Local Planning Panel

184-200 Broadway, Chippendale NSW 2008

D/2024/1165

Alterations and additions to existing commercial building for use as a backpackers accommodation including:

Clause 4.6 Variation Request - Height

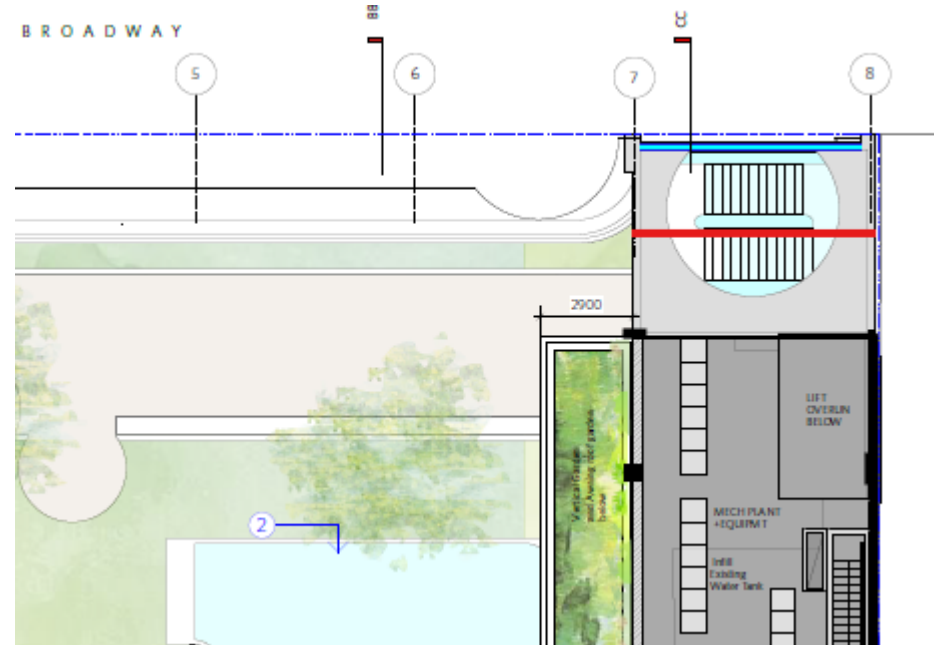
- existing maximum building height is retained
- the existing plant area on the east of the site is being extended towards Broadway to align with the building frontage
- provides a stairwell and architectural feature
- no adverse amenity impacts

Clause 4.6 Variation Request - FSR

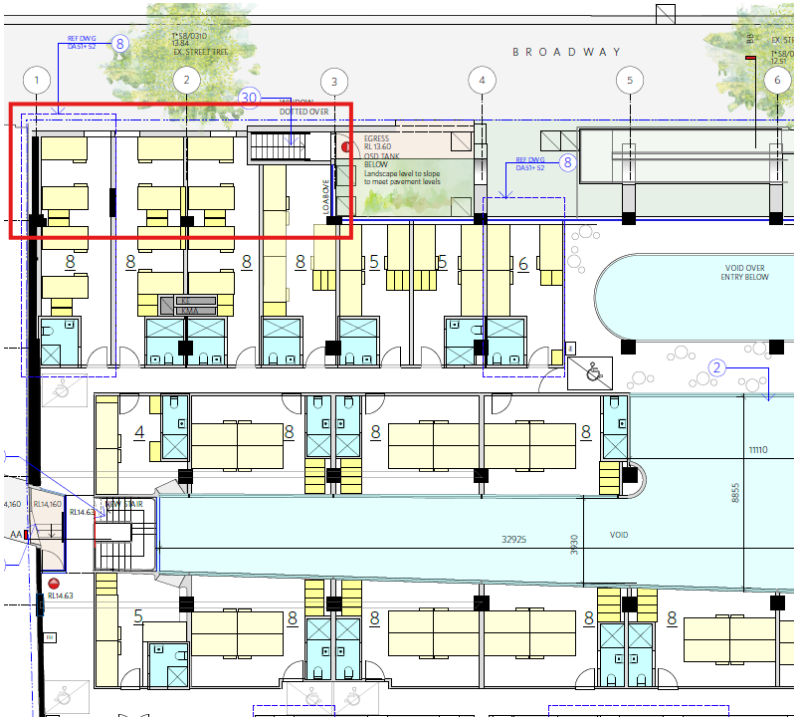
- existing building is over FSR
- the development involves removal of floor space to make way for the void
- facade being brought forward to the Broadway boundary to align with neighbouring sites
- considered to be a positive design outcome
- no adverse amenity impacts

Poor room amenity (first floor)

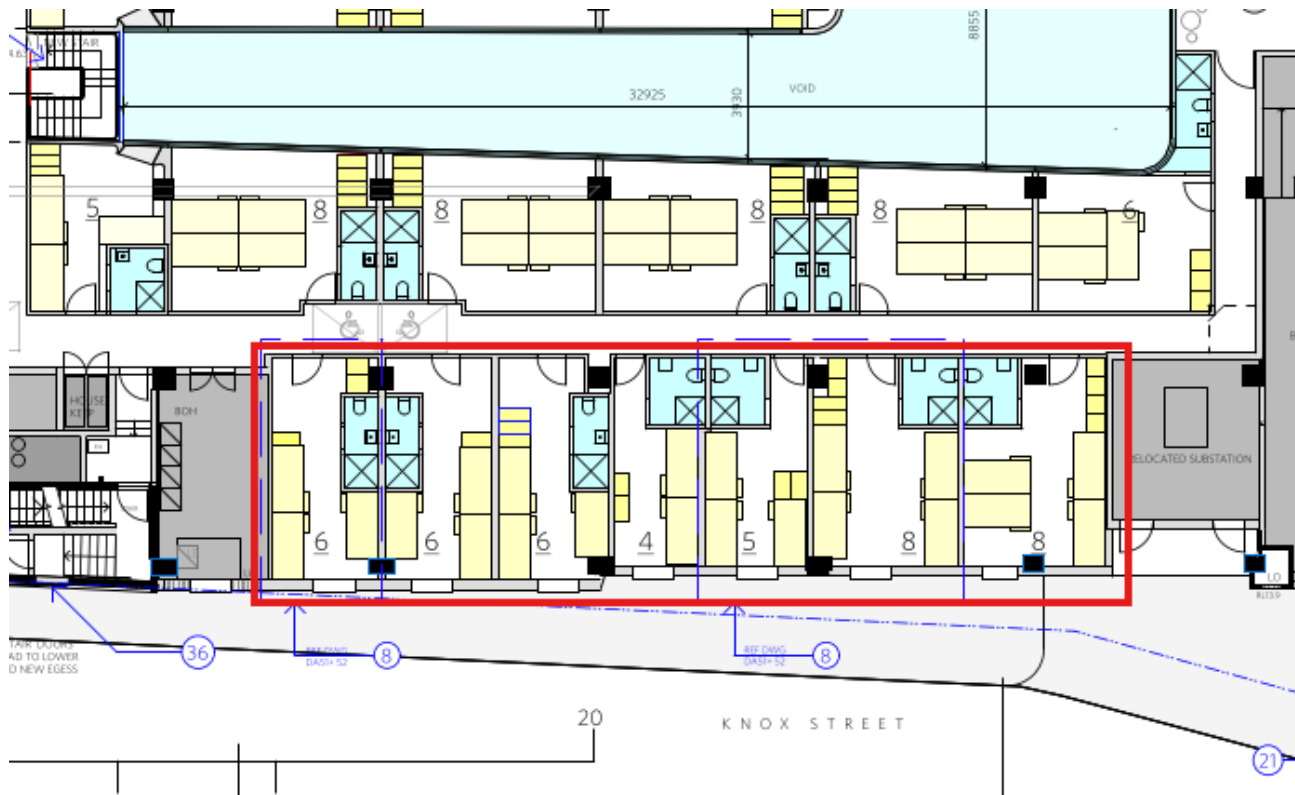
- seven rooms comprising of 43 beds on level 1 have poor amenity
- rooms have windows fronting Knox Street at street level
- privacy and natural light cannot be achieved
- recommended to be removed and replaced with common space
